Work Order ID 84888

Item Name: Skidtube LH

DART SERVICE INSTRUCTION

TO AMEND INSTALLATION INSTRUCTIONS IIN-D209-669 REV. B

INSTALL TOW RING ASSEMBLY AS SHOWN BELOW (REFER TO SECTION F-F OF IIN-D209-669 REV. B.

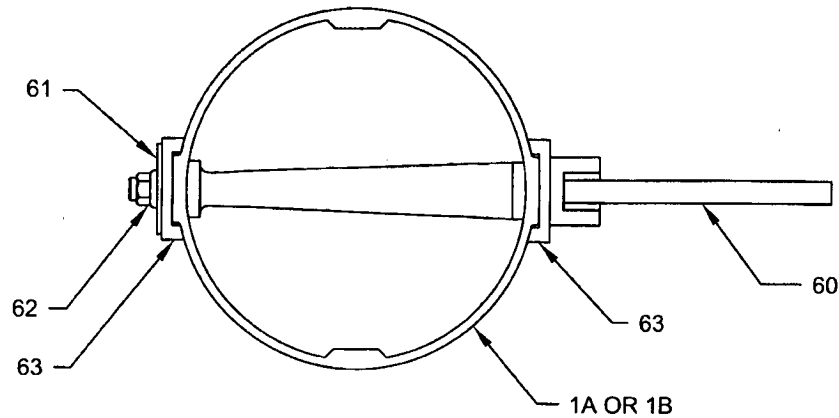
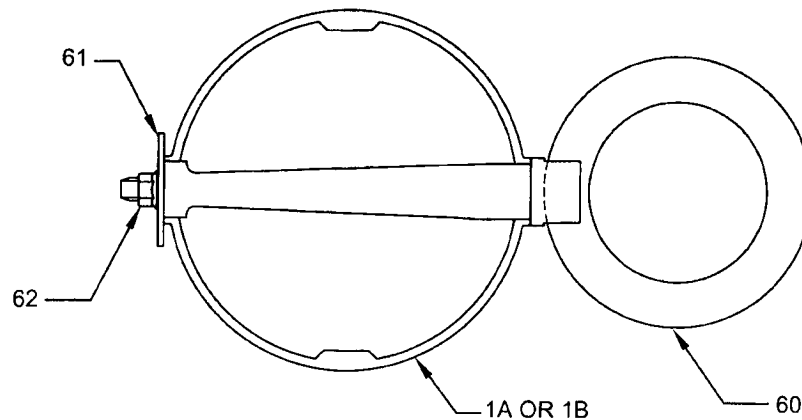
- 1) FOR D209-669-011/-012/-013/-014 SKID TUBES @ CHANGE 003 AND SUBSEQUENT, MODIFY THE FOLLOWING:
 - a) REPLACE THE D2968-041 TOW RING WITH THE D3407-041 TOW RING ASSEMBLY.
 - b) REPLACE THE D2736-1 AND D2736-3 GHW LUGS WITH THE D3405-041 AND D3405-043 LUG ASSEMBLIES.
 - c) AMEND THE PARTS LIST IN SECTION 5.0 OF INSTALLATION INSTRUCTIONS IIN-D209-669 REV. B AS SHOWN ON PAGE 2 OF THIS DSI.

IS:

WAS:
